TITLE: WAIVER OF DESIGN STANDARDS NO. 02018, requested by Ross Engineering, Inc. on behalf of Aspen Builders, Inc., to waive sidewalk and street lights on the east side of S.W. 27th Street, and to waive paving of S.W. 27th Street, associated with the Aspen Ridge 1st Addition final plat, generally located at S.W. 27th Street and West "A" Street.

P.A.S.: Waiver of Design Standards #02018

PROPOSAL: Waive sidewalk and street lights on the east side of S.W. 27th Street and paving of S.W. 27th Street associated with Aspen Ridge 1st Addition final plat.

ASPEN RIDGE 1ST ADDITION

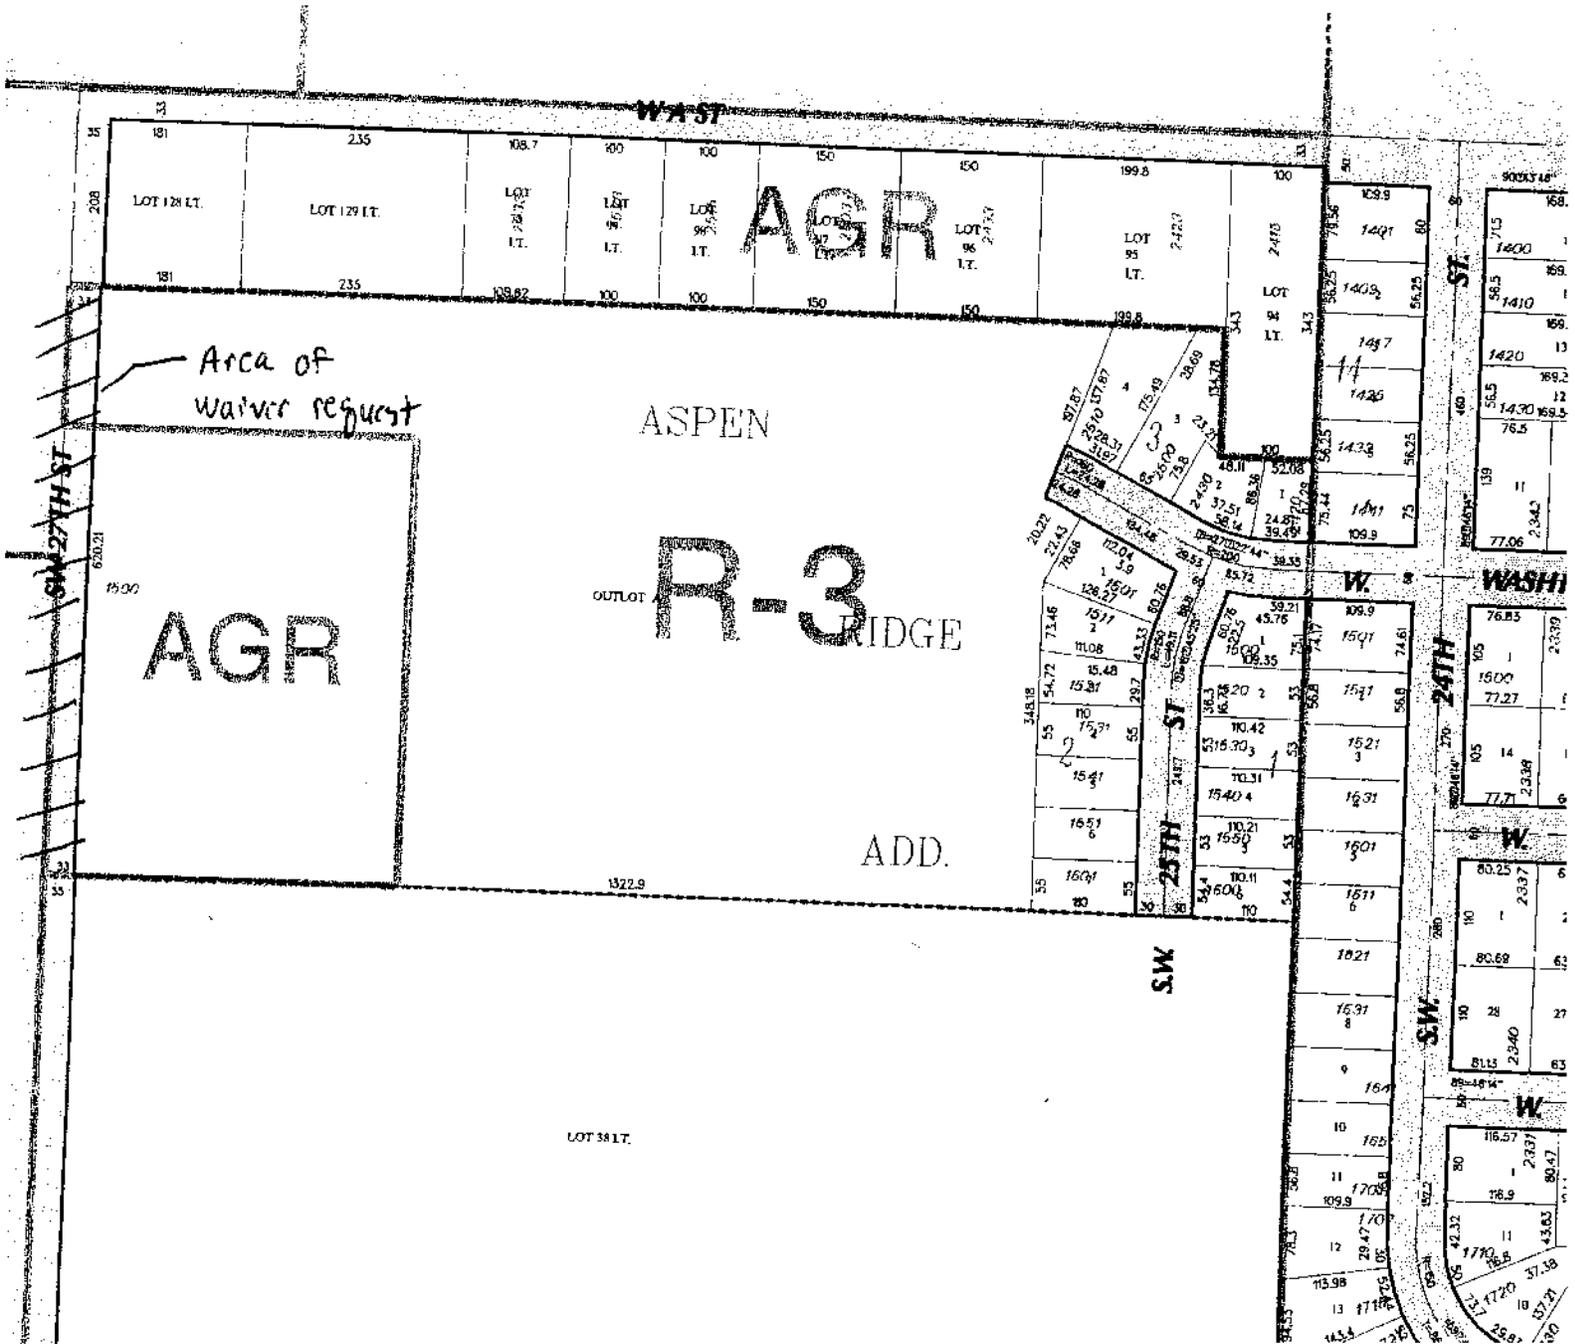
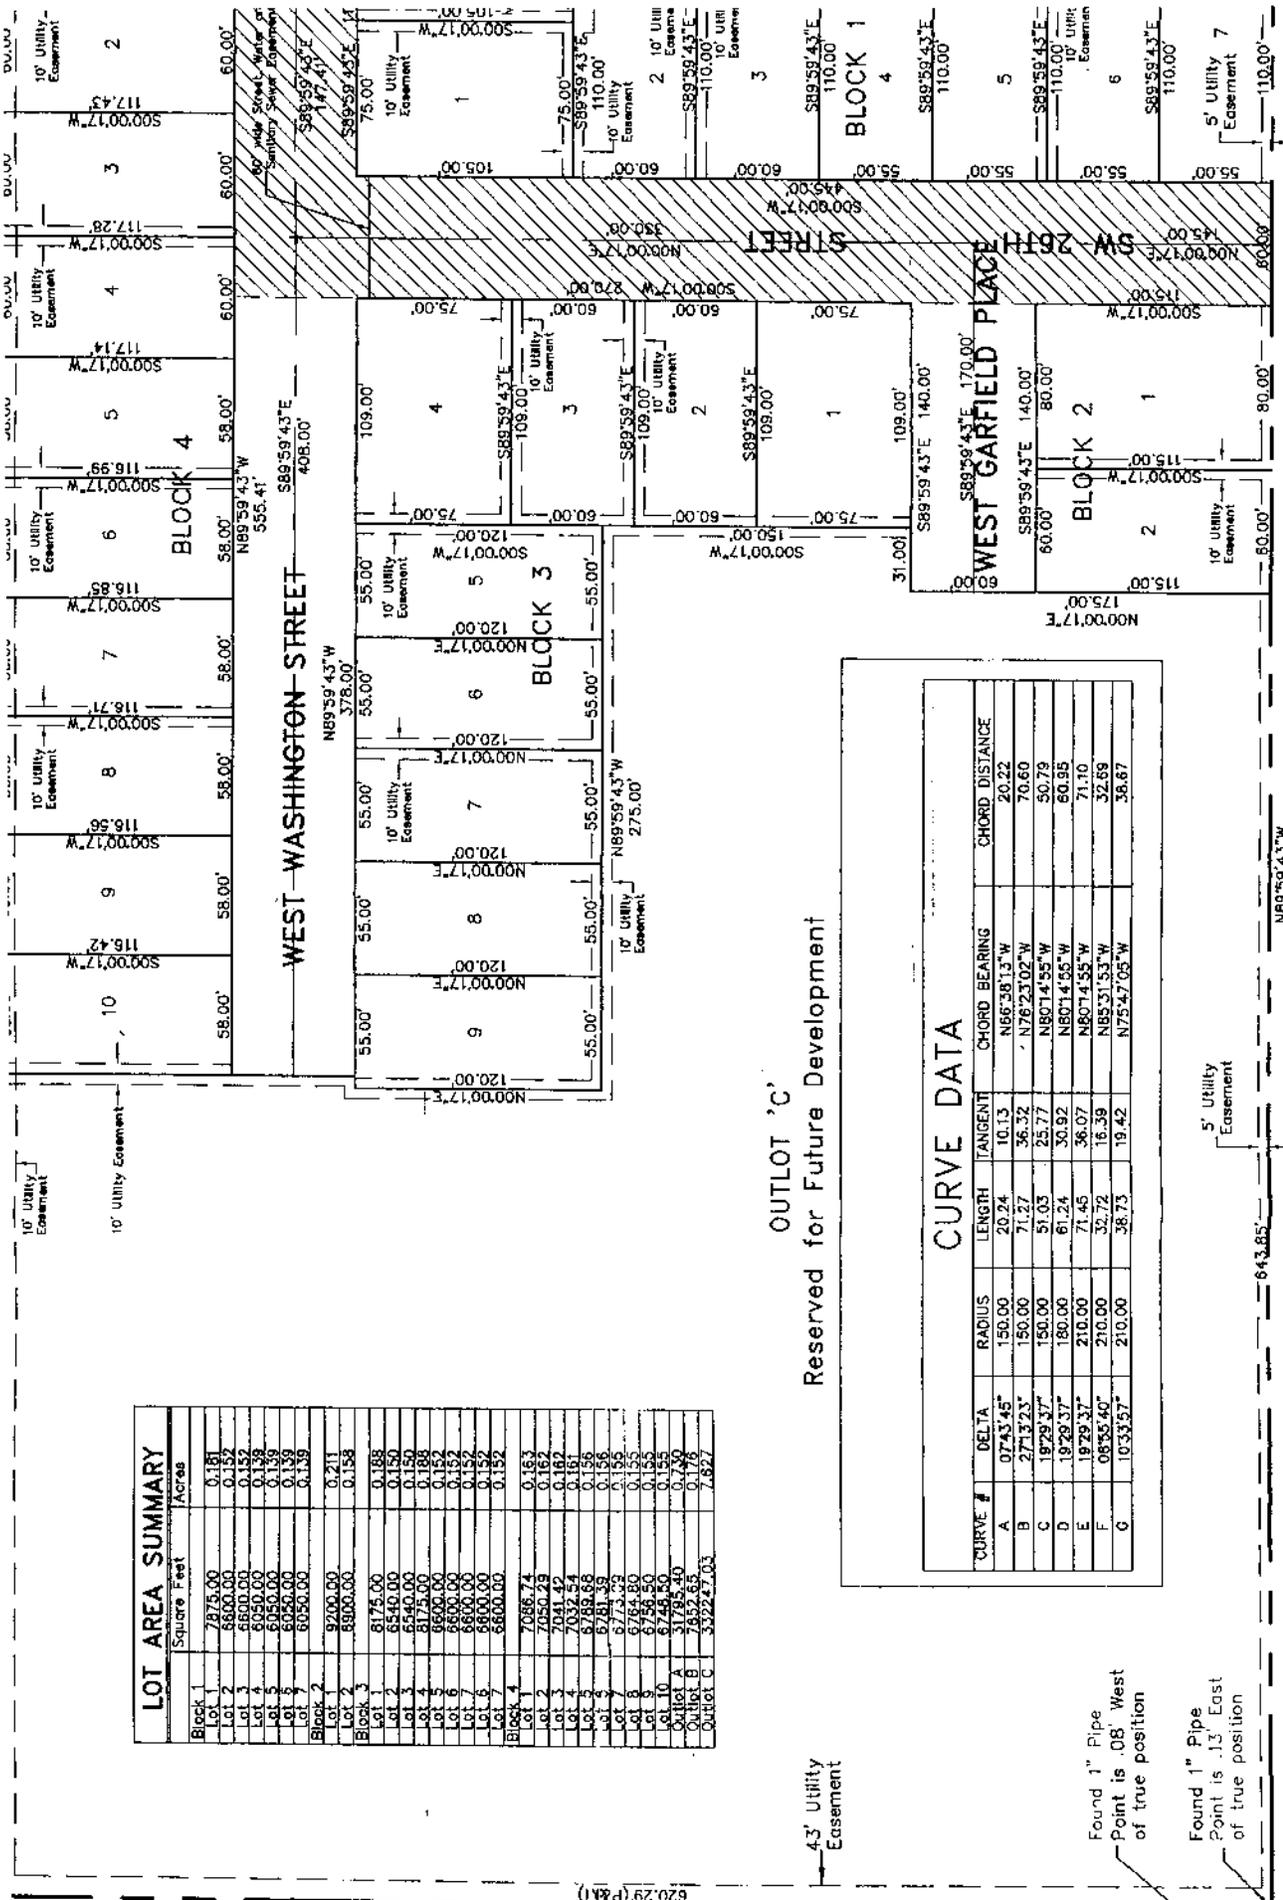
1. This request is to waive the sidewalk and street lights on the east side of S.W. 27th Street (Sec. 26.23.095 and 26.27.070) and street paving of S.W. 27th Street (Sec. 26.27.010).

2. The applicant's letter states that the city has requested sidewalks on both sides of S.W. 27th Street. The sidewalk is only required on the side of S.W. 27th Street abutting the final plat of Aspen Ridge 1st Addition.

3. The applicant's letter requests a waiver to landscaping. The preliminary plat of Aspen Ridge did not require landscaping or street trees on S.W. 27th Street.

4. Public Works supports the waiver of the paving and sidewalk on S.W. 27th Street until the time that W. Washington Street is platted to complete the connection with S.W. 27th Street.

5. There are no buildable lots being platted with the final plat of Aspen Ridge 1st Addition abutting S.W. 27th Street. Traffic on S.W. 27th Street most likely will not increase with the approval of Aspen Ridge 1st Addition final plat.

The developer has requested waivers to subdivision requirements for paving, street lights and sidewalks in Southwest 27th Street adjacent to Aspen Ridge 1st Addition. Since this plat is platting an outlot reserved for future development and is not platting any streets or lots that take access to Southwest 27th Street other than the outlot Engineering Services recommends, these requirements should be waived with this plat. This requirement should be imposed when buildable lots are platted with Southwest 27th Street frontage or a street is platted accessing Southwest 27th Street.

<u>RECOMMENDATION:</u>	Approval with the condition that when W. Washington Street is connected with S.W. 27 th Street, all improvements will be required.
-------------------------------	---
